24 Heath Drive, London,
NW3 7SB

Basement Impact Assessment
Audit

For
London Borough of Camden

Project Number: 12727-71

Figure 1: Displacement profile for front wall of No.23.

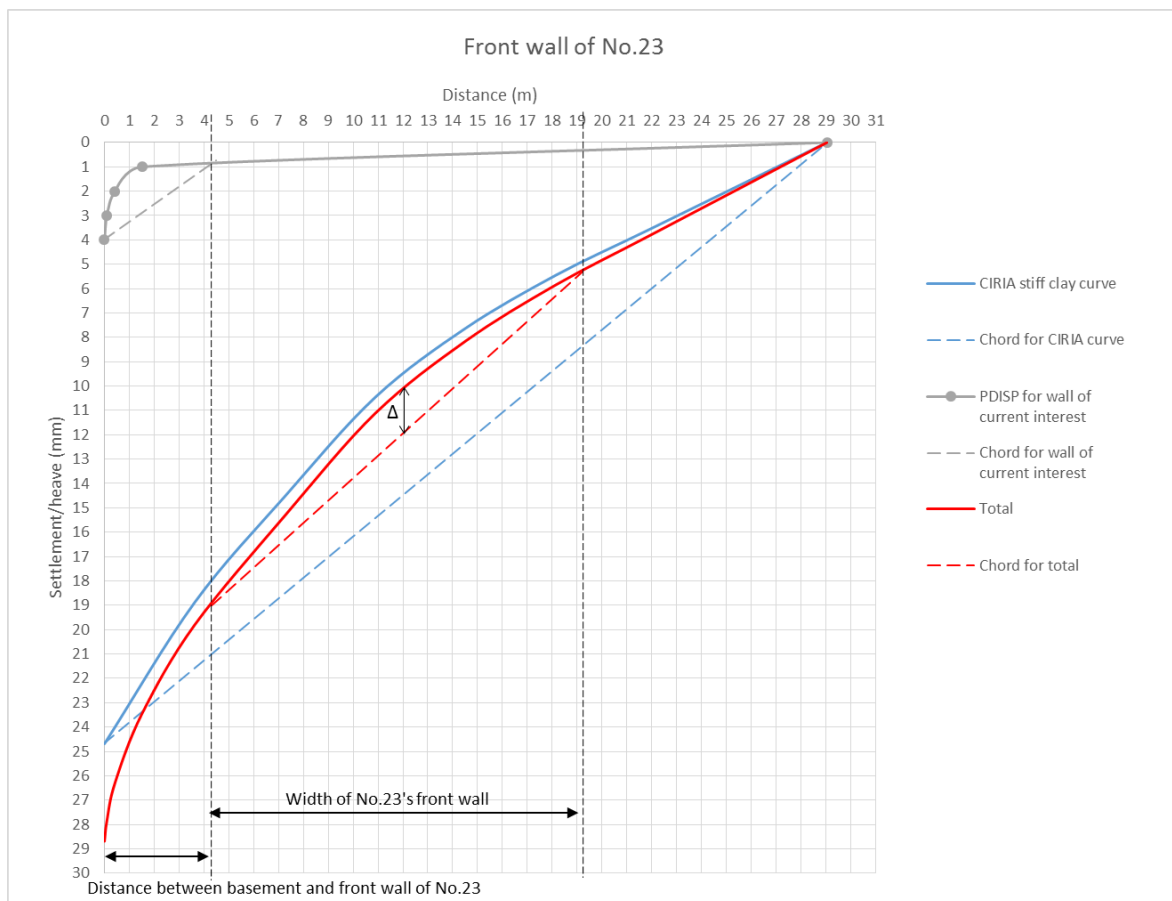
- 1.2 Camden's auditors for BIAs, Campbell Reith Hill LLP, have asked for additional assessments to be carried out in order to confirm that the potential for damage to No.23 Heath Drive as a result of the construction of the proposed basement beneath No.24 would also be within acceptable limits. These damage category assessments have considered movements arising from the two-storey part of the proposed basement beneath the north-east side of No.24, as well as movements arising from the proposed perimeter Bored Pile Wall (BPW) at the rear of the house.

Width of No.23's front wall (L) = **14.94m** (closest point located **4.30m** from No.24's basement; see Figure 1 below)

- 2.5 Thus, for the anticipated (theoretical) horizontal displacement of **10mm** (increased pro rata for a typical two-storey deep basement, as a worst case scenario, based on a typical value of 5mm for a single-storey basement, with a depth of around 3.5m), the strain beneath the front wall of No.23 would be in the order of $\epsilon_h = 3.44 \times 10^{-4}$ (0.034%).

- 2.6 The maximum settlement predicted by the PDISP analysis adjacent to the front wall of No.23 was 4mm in Stage 1, though very similar movements were also predicted in stages 2 & 3 (see Figure G3 in Appendix G). This must be combined with the settlement caused by relaxation of the ground alongside the basement in response to excavation of the underpins, which can be estimated using the settlement profile for the worst case (low stiffness) scenario presented in Figure 6.13(b) of CIRIA Report C760. The settlement profiles are then summed to find the maximum deflection, Δ . Figure 1 presents these settlement profiles for No.23's front wall. The maximum $\Delta = 1.94\text{mm}$, which represents a deflection ratio, $\Delta/L = 1.30 \times 10^{-4}$ (0.013%).
